**Re: FINAL SAMPLING AND ANALYSIS PLAN ADDITIONAL INVESTIGATION AT  
SITE 22- SOUTHWEST FENCE LINE AND SEAL CREEK, NAVAL WEAPONS  
STATION SEAL BEACH, DETACHMENT CONCORD, CONCORD,  
CALIFORNIA**

**Final**

## **Sampling and Analysis Plan**

# **Additional Investigation at Site 22 – Southwest Fence Line and Seal Creek**

**FIGURE 3**  
**PROPOSED SURFACE SOIL SAMPLING**  
**LOCATIONS IN THE MAGAZINE AREAS**

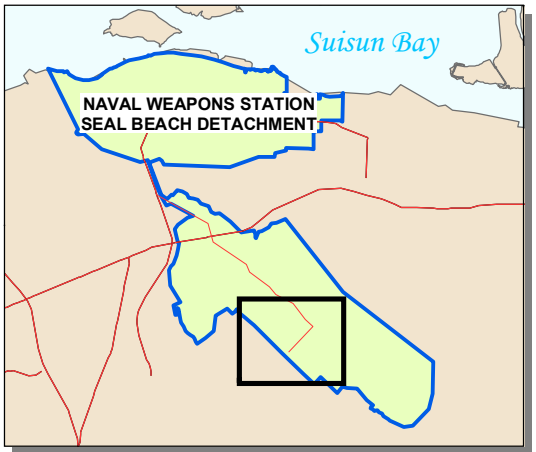
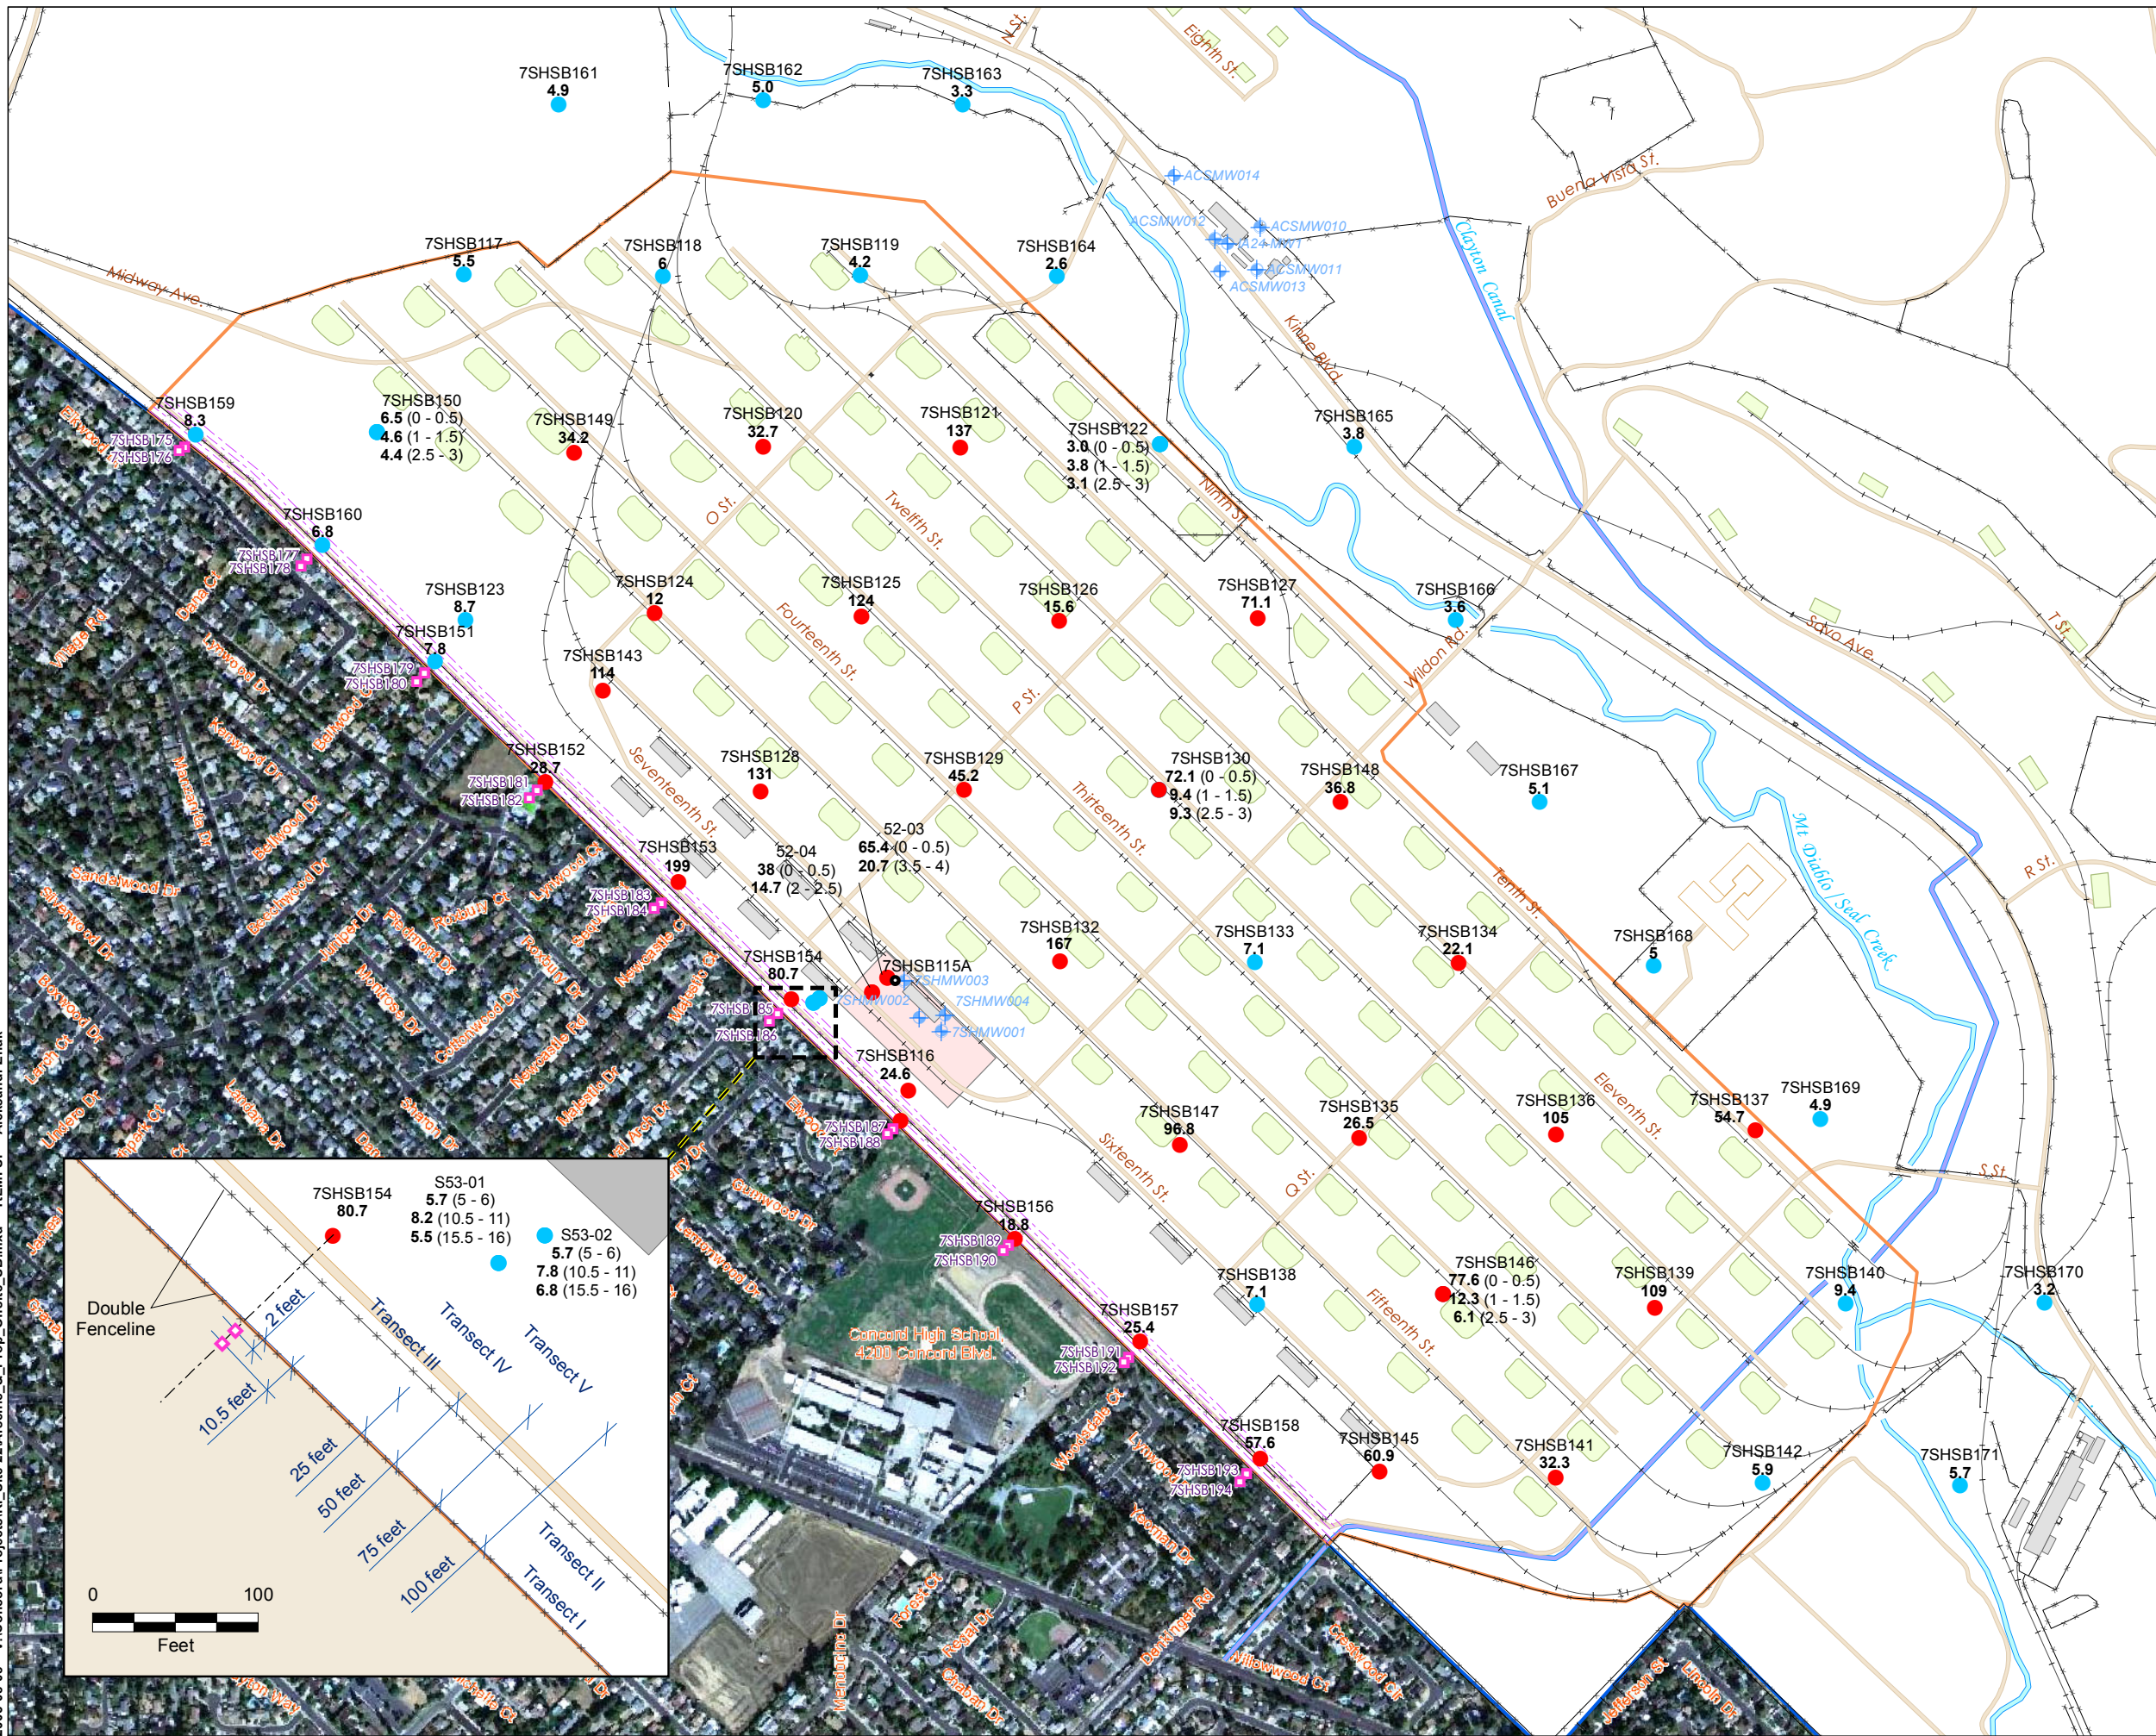
5. **Comment:** **Section 1.2.1, Project Objectives (Magazine Area A-D Assessment); and Figure 3, Proposed Surface Soil Sampling Locations in the Magazine Areas:** As indicated above in General Comment number 1, U.S. EPA believes additional sampling data should be collected from Magazine Areas A-D to better characterize the lateral and vertical extend of soil contamination associated with the Magazine Areas. At a minimum, U.S. EPA requests that the Navy double the number of samples proposed for each Magazine Area and U.S. EPA requests that the Navy utilize more detailed sampling objectives to better assess contaminant concentrations is subareas of the sites; for example, soils placed on top of individual bunkers, soils adjacent to railroad ballasts, sediment in drainage ditches, and soils in open spaces. U.S. EPA has noted that previous sampling activities around Building 7SH5 detected elevated concentrations of arsenic adjacent to railroad ballasts; however, the Navy has not proposed additional sampling in Site 22 study area to confirm the extent of contamination along other Navy railroad right-of-ways. Also, the Navy should assess surface water flow paths in Magazine Areas A-D, and integrate any surface water flow features into the investigation.

2. **Comment:** Page 4, Figure 3. It is unclear whether the locations proposed for surface sampling in Areas A to D were selected with a consideration of potential for surface runoff into Clayton Canal. This would be based upon gradient, distance to the creek, and perhaps other considerations.

**Response:** Magazines A through D in the Inland Area have not previously been evaluated for the presence of arsenic in soils. This initial phase of sampling is intended to assess whether arsenic-containing herbicides were applied in these areas in a fashion similar to the Site 22 Magazine Area. The proposed sampling and analysis for these four areas is meant to provide a Site Inspection (SI) level of data that can confirm or deny the need for an RI. Figure 6B has been added to the SAP to depict surface drainage pathways in Magazine Areas A through D based on topography.

*The Navy has added 10 additional samples within the Inland Area Magazines A through D, as shown on [Figure 3](#).*

FIGURE 6A  
SURFACE DRAINAGE MAP

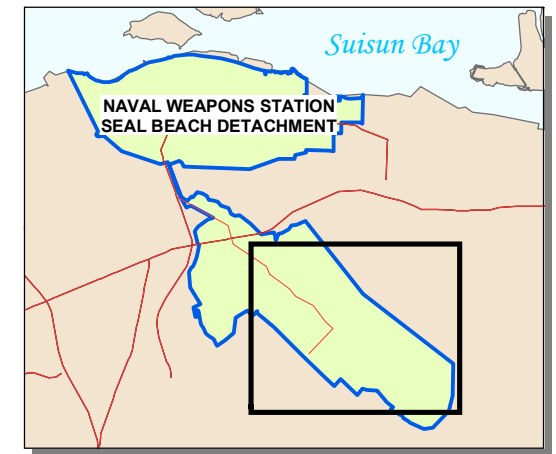
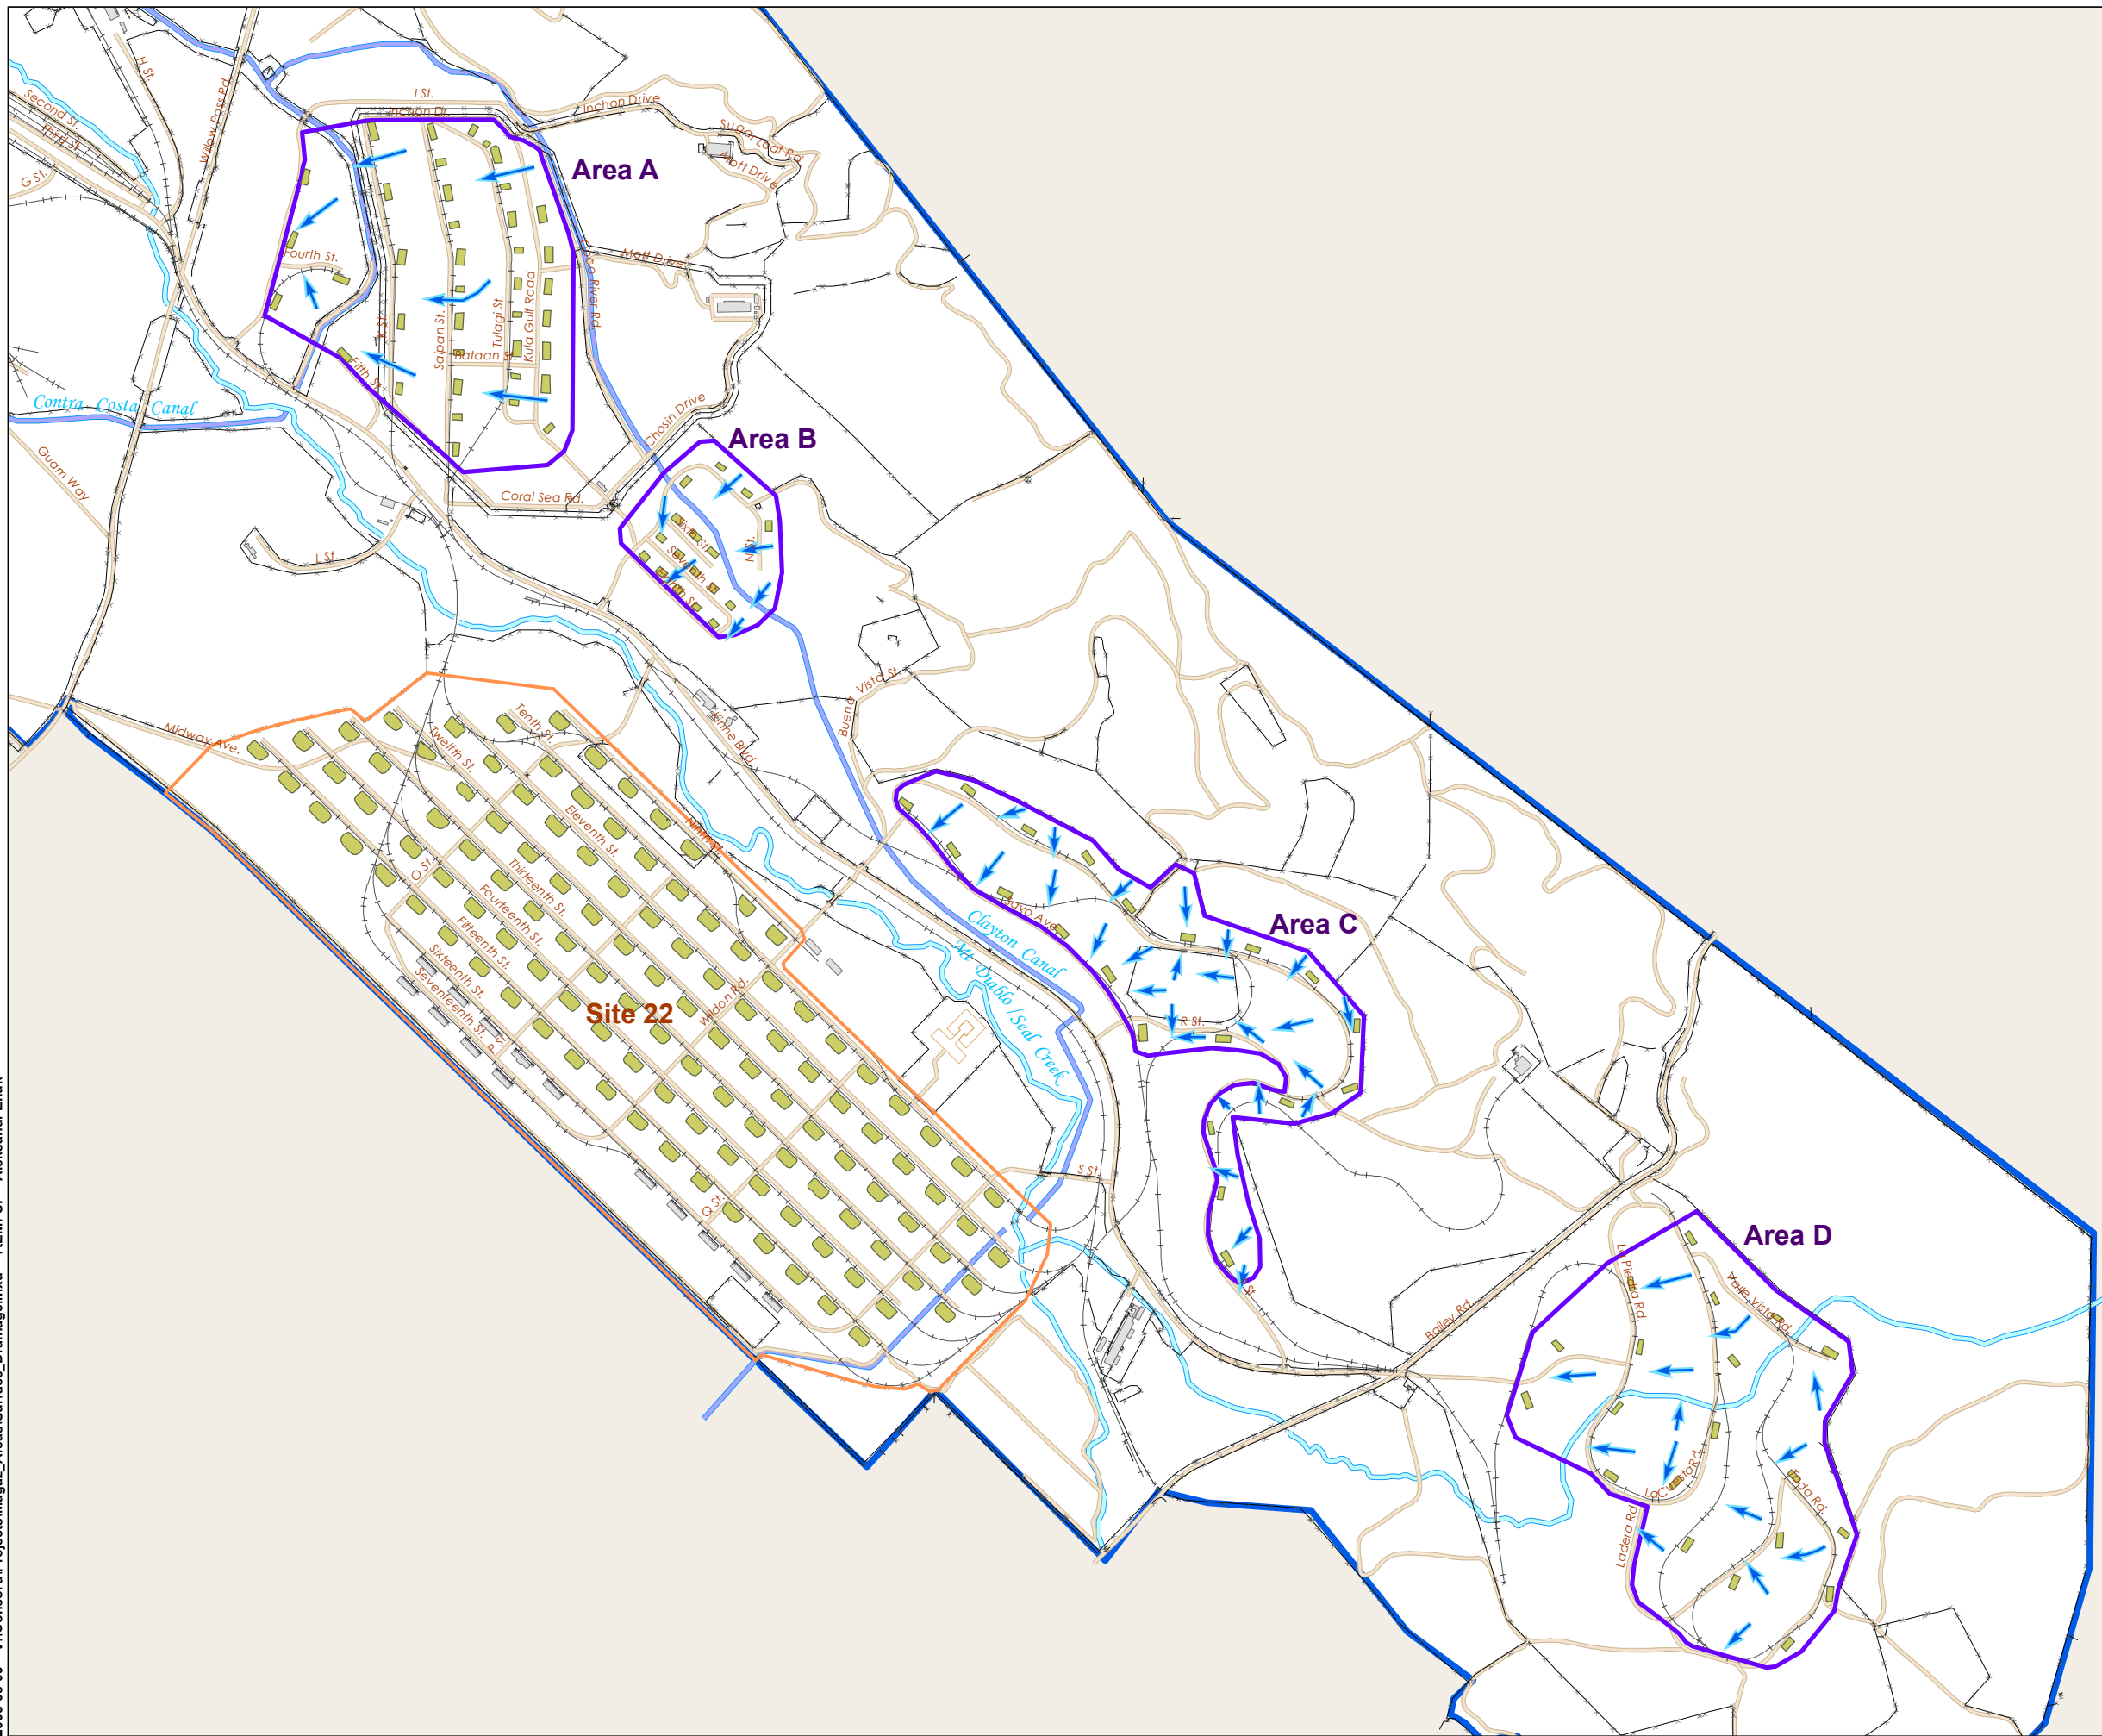
10. **Comment:** **Figure 6, Surface Drainage Map: The southern end of the Main Magazine Area is identified as Surface Drainage Area “G” and indicates, “Drains to Clayton Canal”. Acknowledging that California Fish and Game has raised issues with regards to surface flows at Magazine Areas A-D in their July 1, 2005, Site 22 Sampling and Analysis Plan review, U.S. EPA requests that the Navy assess sediment in Clayton Canal at Drainage Area G. This section of canal was sampled by the Regional Board earlier this year and had arsenic detected in sampled standing water. While U.S. EPA does not believe that the abandoned Clayton Canal north of Mount Diablo Creek has the capability to transmit sediment south beneath the creek (because the siphon structure cannot function without full flows in the canal), sediment collected in the canal south of the creek may be transported south where the canal travels into the Dana Estates neighborhood (U.S. EPA’s assumption on the Clayton Canal is that the structure was designed to transfer surface water from the Contra Costa Canal southeast into Clayton for irrigation purposes). The Navy should confirm the direction Clayton Canal flowed and the existence of any control structure that could restrict sediment transport as part of its investigation.**

4. **Comment:** Page 11, Figure 6 (Surface Drainage Map). Drainage into Clayton Canal should be accounted for in this figure. Please also include a figure similar to figure 6 that shows surface water flow in Magazines A through D.

**Response:** As shown on [Figure 6A](#) of the SAP, only a small portion of the southeastern corner of the magazine area (approximately 25 acres of 531 acres) drains surface water runoff into the Clayton Canal. As shown on [Figure 4](#) of the SAP, concentrations of arsenic in the two soil samples collected to date from that portion of the site (7SHSB140 and 7SHSB142) were below the background concentration established for the site, of 10 milligrams per kilogram (mg/kg). No barriers other than natural vegetation exist to prevent soil or surface water from draining into the canal. The Clayton Canal, which branches from the Costa Contra Canal and is approximately 4.85 miles in length, has been abandoned since 1985. According to Jeff Quimby of the Contra Costa

**Response:** Drainage into the Clayton Canal is indicated in “Area G” of [Figure 6A](#). A figure that shows drainage within Inland Area A through D based on topography has been added as [Figure 6B](#).
